AGENDA
PLAN COMMISSION
Buechner Room, 1st Floor
Arlington Heights Village Hall, 33 S. Arlington Heights Rd.
Arlington Heights IL 60005
November 12, 2025
7:30 PM

**Plan Commission
11/12/2025**

PC File Number: PC 25-018
Project Title: Tasty Breads PUD Amdt.
Address: 600 W. University Drive (Ref. Exhibit A – Aerial & Exhibit B – Plat of Survey)
PINs: 03-07-200-054; 03-07-200-055

To: Planning & Community Development
From: Div. Chief Dave Roberts
Department: Fire Department
File Number: PCA00018-2025
Project: 600 W University Drive
Review Round: Round 1
Date: October 1, 2025

Description SITE PLAN

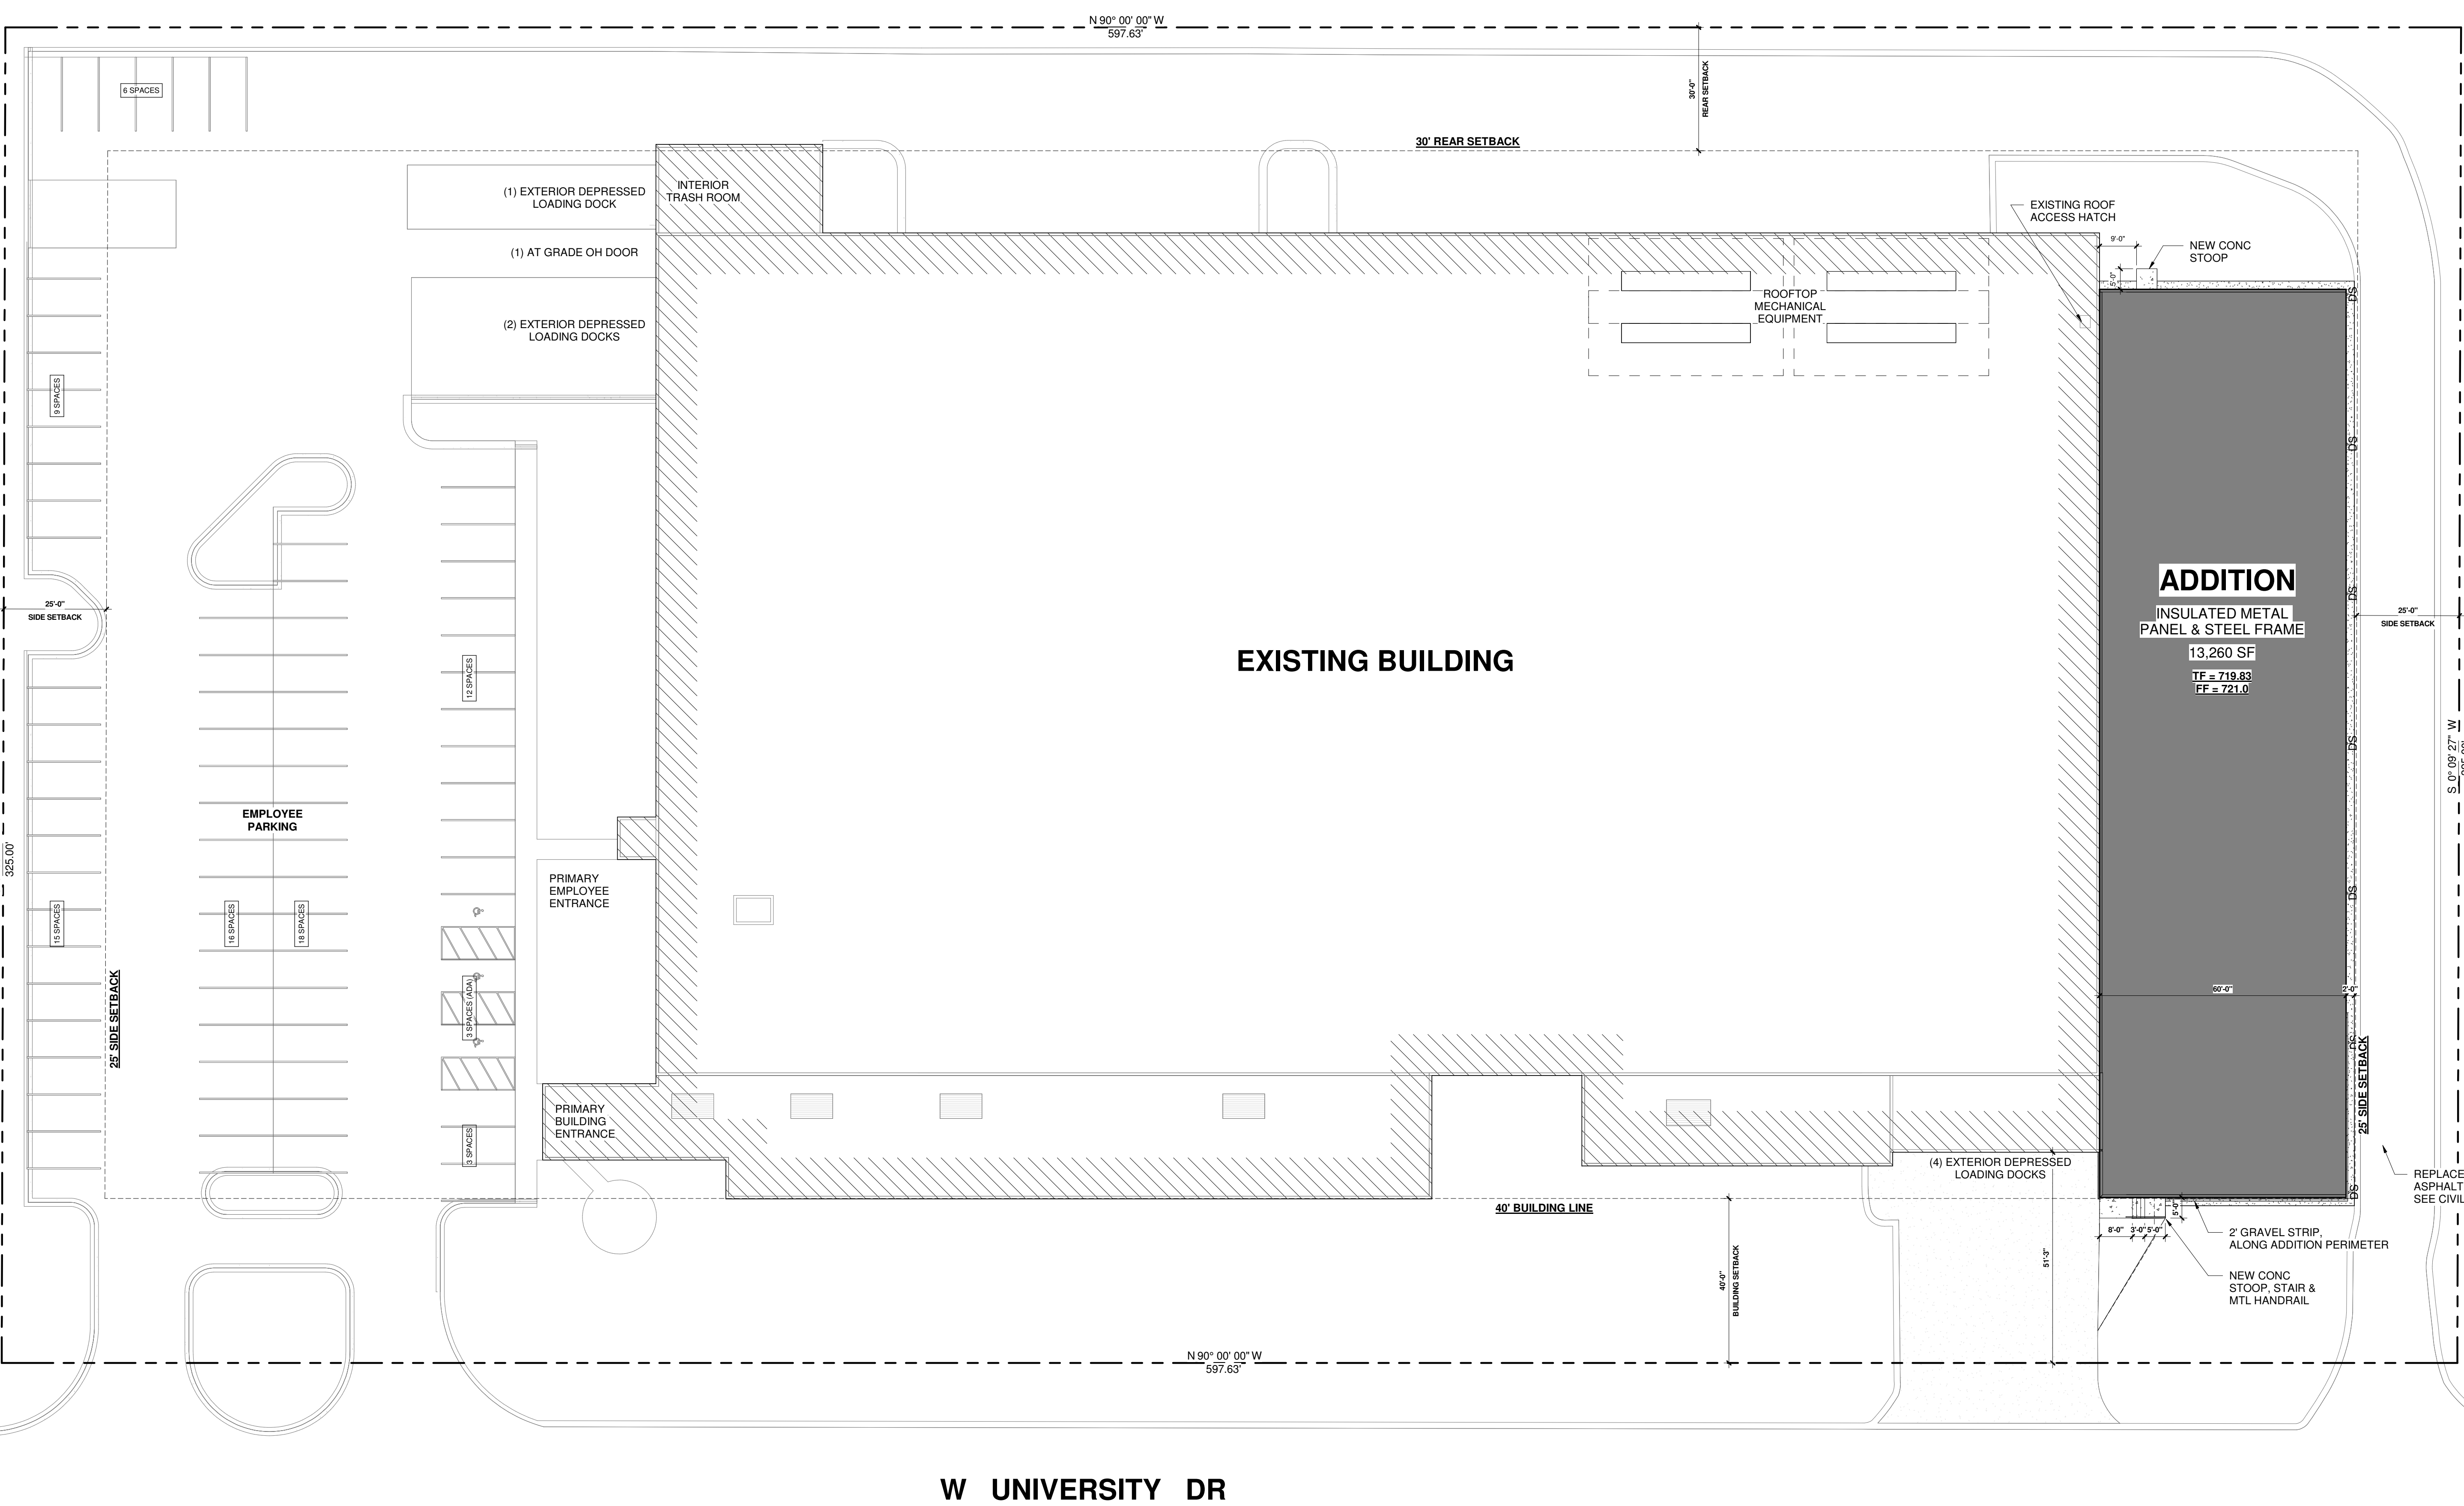
1. Fire separation is required between S-1 and S-2 Occupancy.
Section: 2018 IBC T508.4
2. An autoturn diagram is required to confirm fire apparatus access. Sheet EX-1 is not provided for review
Section: 2018 IFC 503.2.4 and Appendix D D103.3

3. Provide the height of rack (5X high) and clearance between top of rack and bottom of sprinkler head.
4. Aerial fire apparatus is required since the grade plane and the highest roof surface exceeds 30 feet. Provide a section through the exterior wall indicating the building height from the grade plane.
Section: 2018 IFC D105.1
